## Product Change Notification: CENO-13CPHA326

CCB 7197 Final Notice: Qualification of MMT as an additional assembly site for HV9925SG-G, SR037SG-G, SR036SG-G, CL320SG-G, CL7SG-G, SR087SG-G, SR086SG-G, HV809SG-G, CL325SG-G and CL330SG-G catalog part numbers (CPN) available in 8L SOIC (3.90mm) package.

**CCB 7197**  
**Pre and Post Change Summary**  
**PCN #: CENO-13CPHA326**

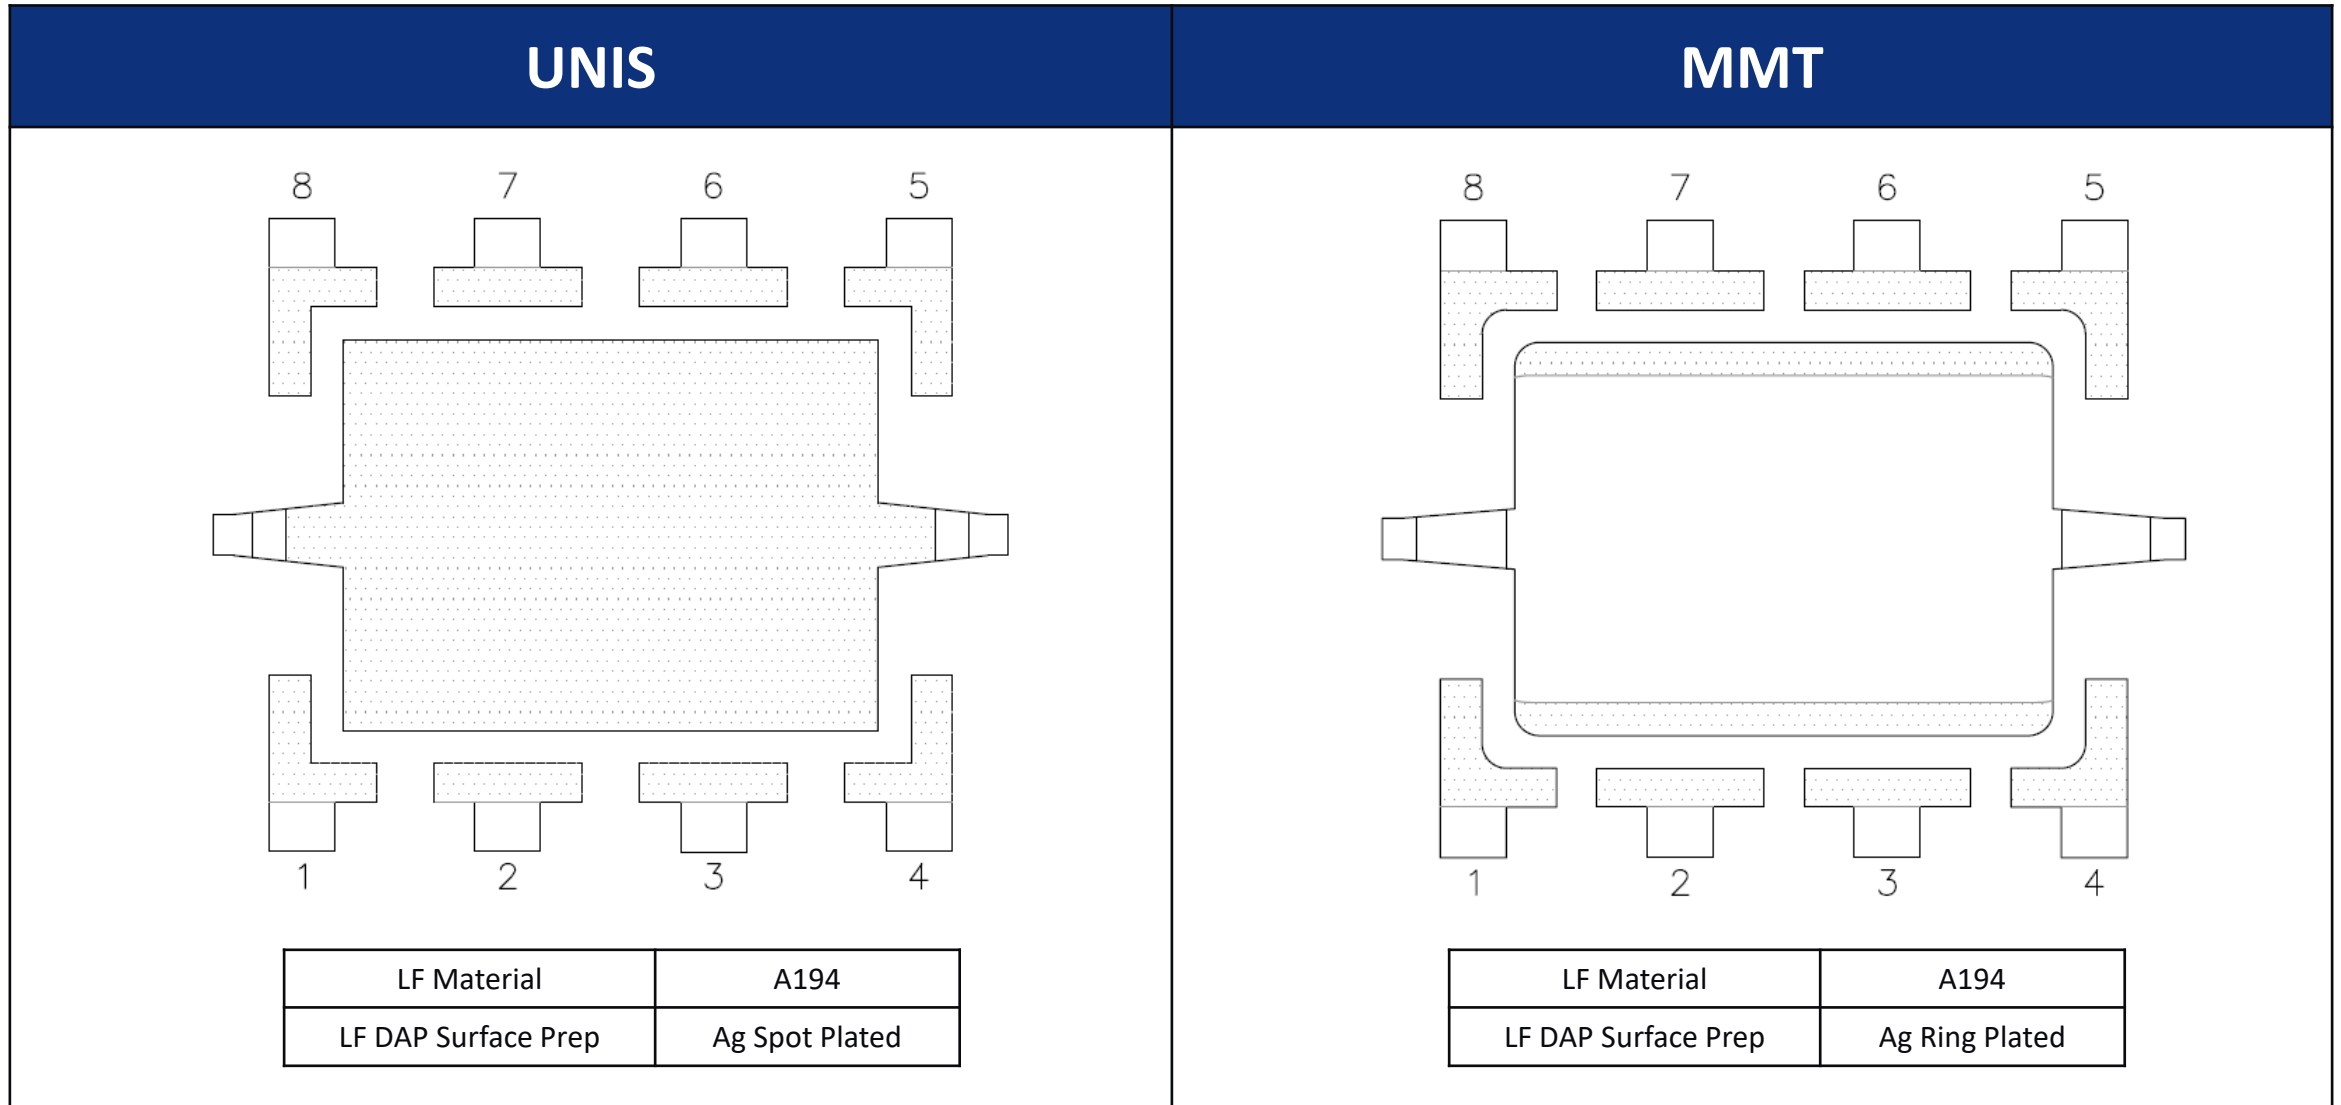
Pre Change	Post Change	
Assembly Site	Unisem (M) Berhad Perak, Malaysia	Unisem (M) Berhad Perak, Malaysia (UNIS)	Microchip Technology Thailand (Branch) (MMT)
